FOLK Friends of the Land of Keweenaw  
Grassroots Stewards of the Western Upper Peninsula

January 23, 2019

**RE: Comments on the Draft Permit to Install (Permit No. 128-18) Proposed for L'Anse Warden Electric Company, LLC (LWEC) by the Michigan Department of Environmental Quality (MDEQ).**

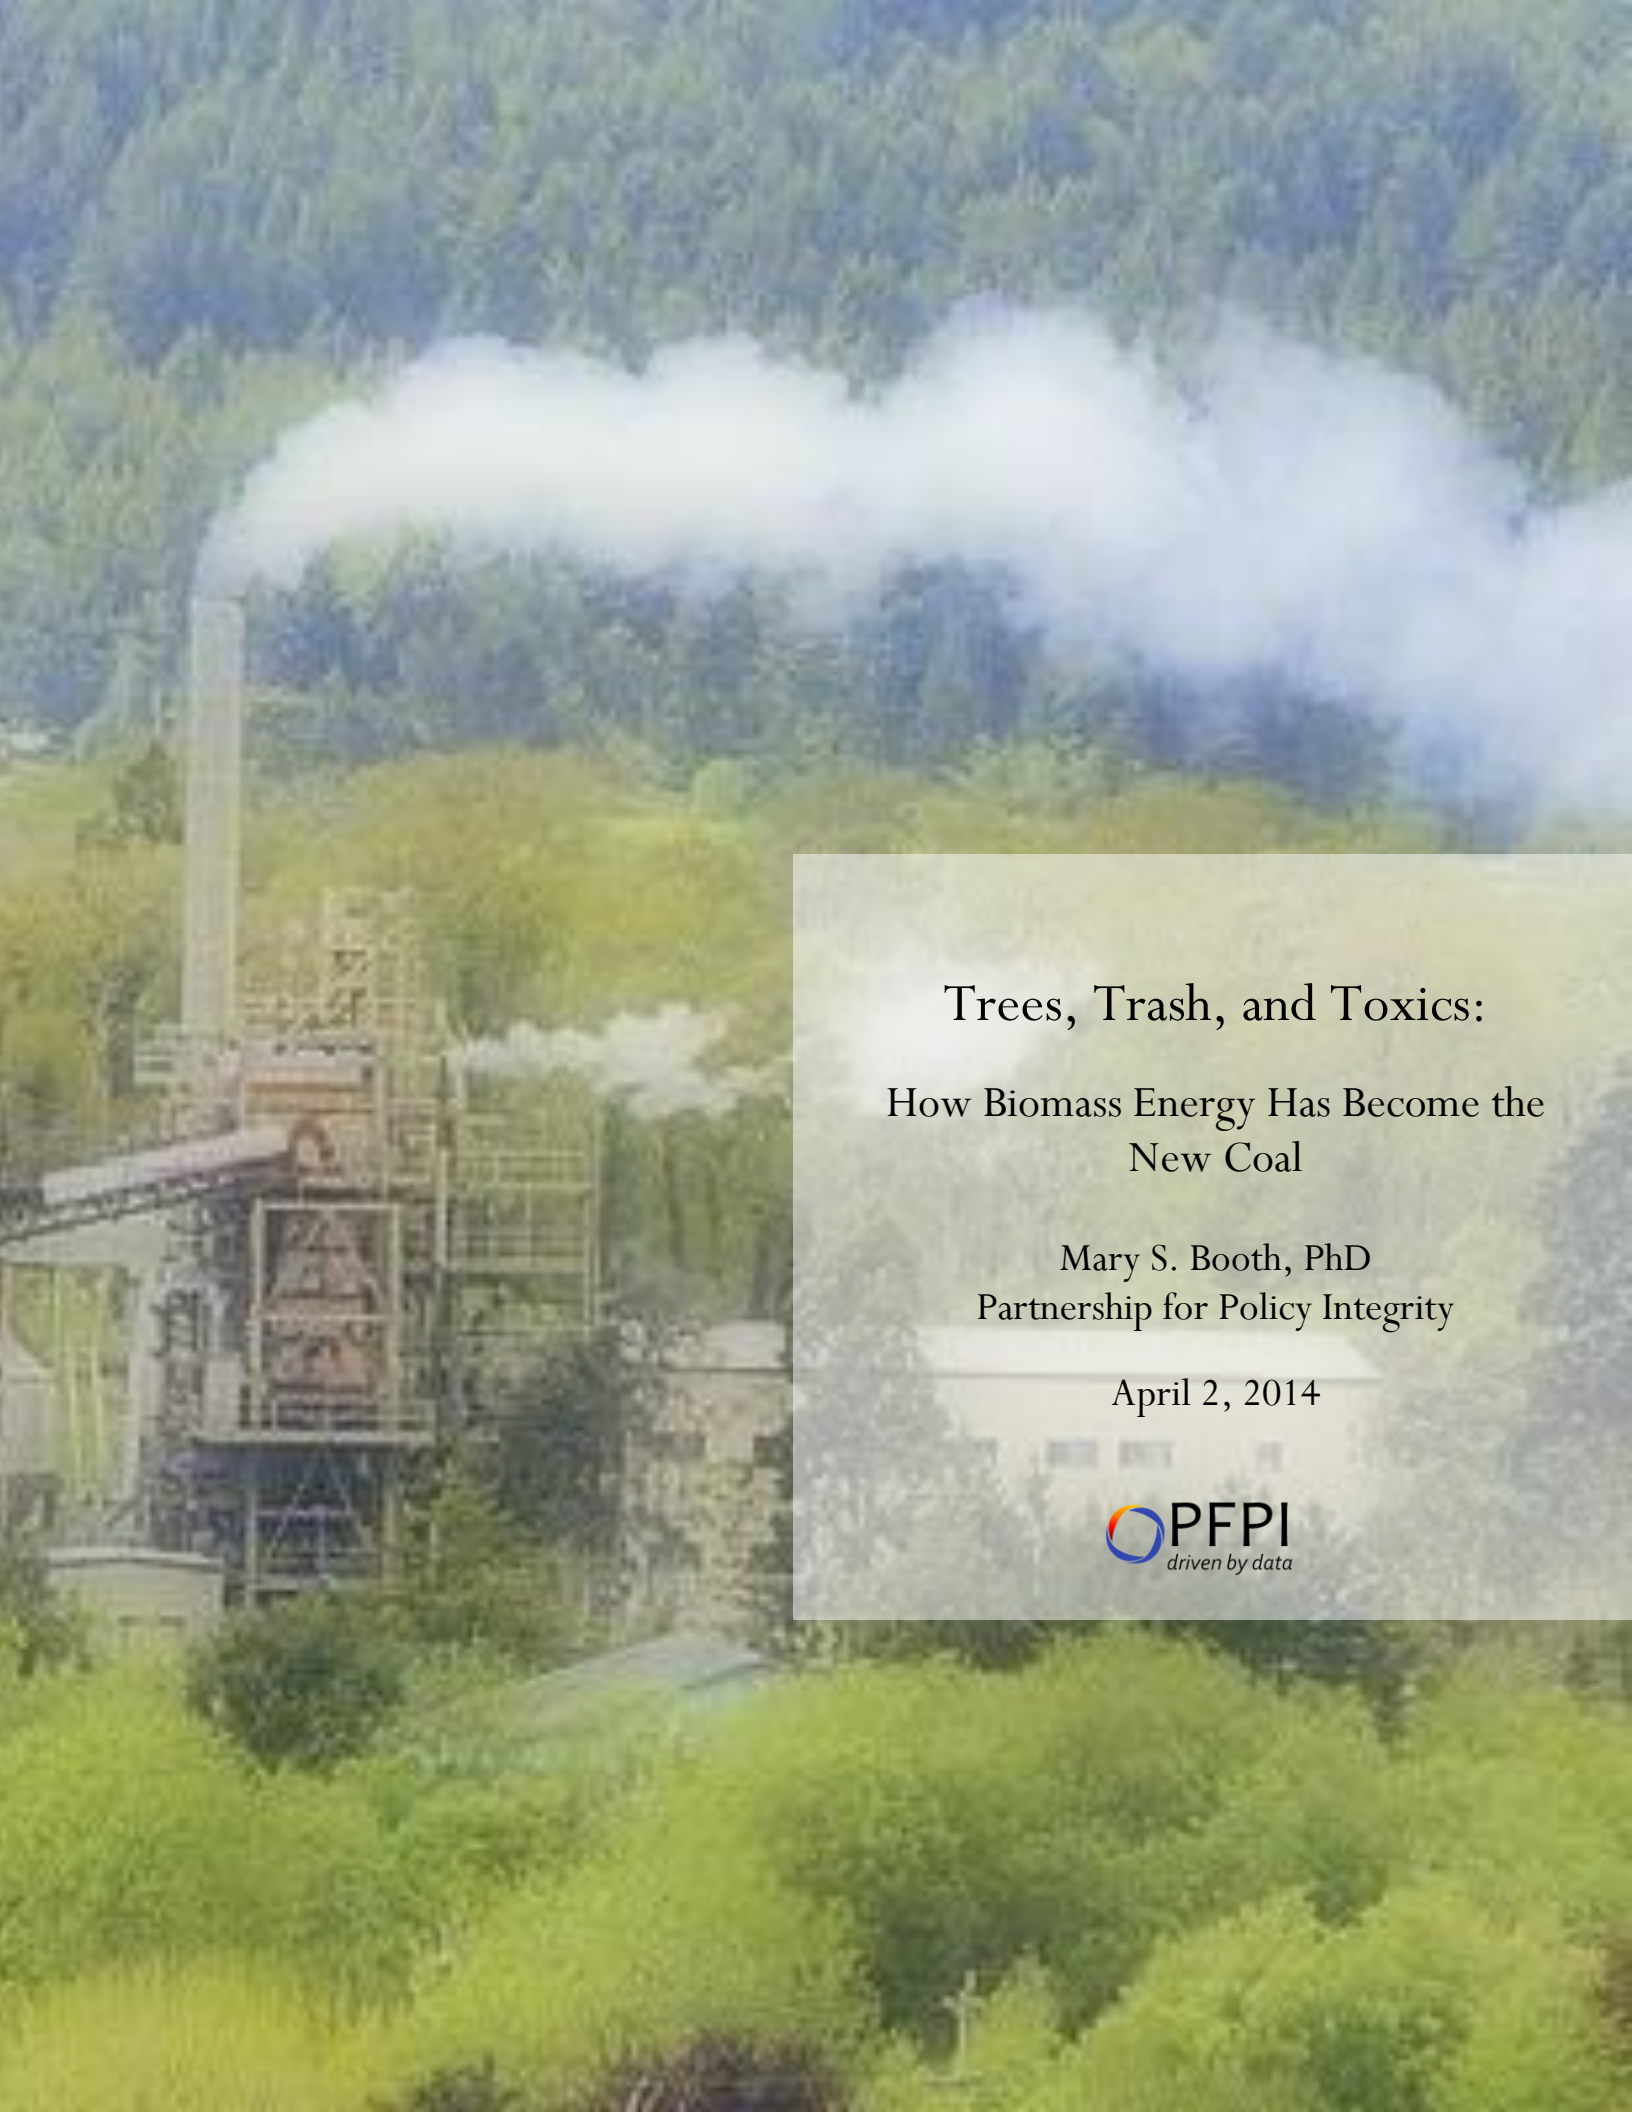
Notes:

1. AP-42 emission factors are from § 1.6 Wood Residue Combustion in Boilers.
2. As discussed in our comments, we do not believe TDF and plastic pellets emit HAPs at lower rates than wood, let alone 50% lower, however we provide this scenario to demonstrate that LWEC's use of TDF and pellets cannot justify exempting LWEC from major source MACT.
